Cylinder Block Caution on 2017-2019 Ford 2.0L Ecoboost Engines

Figure 1: The slot between cylinders shown above in red circles.

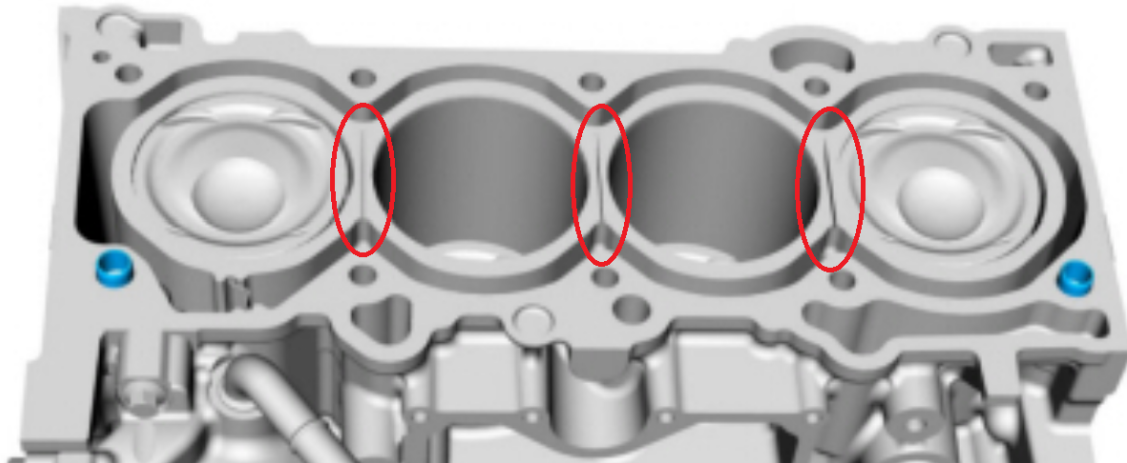
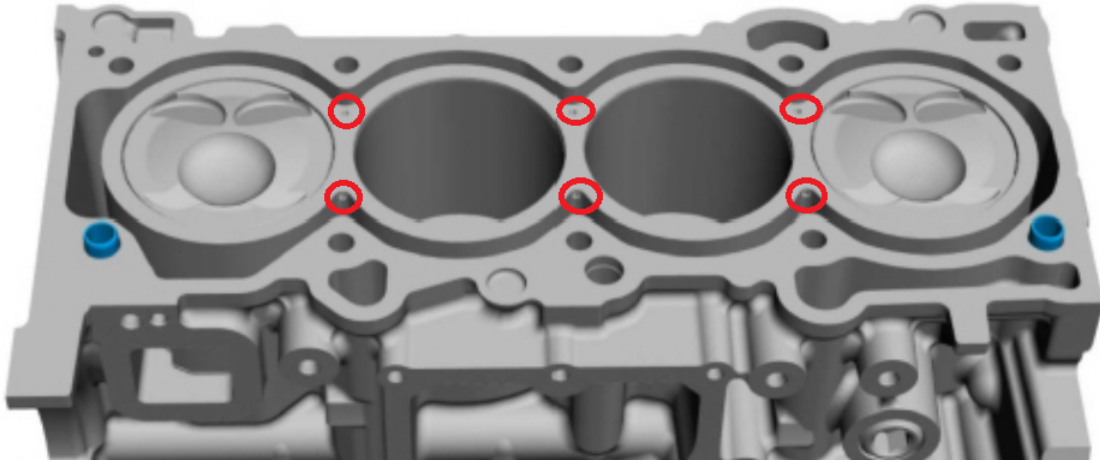
There has been discussion that the slot cast between the cylinders does not provide enough clamp load surface area to properly seal the head gasket. At the printing of this bulletin, AERA does not have any documentation to verify the claim and is only cautioning our members of the problem. See Figure 1 for slot design. Ford has removed the slot starting in 2020 and instead cross drilled to allow coolant flow between cylinders. This provides more surface area to seal against. See Figure 2 for cross drilled design.

Figure 2: Slot between cylinders removed and the block is cross drilled between cylinders. The coolant flows through the head, block and head gasket then across to the side of the cylinder locations circled in red.
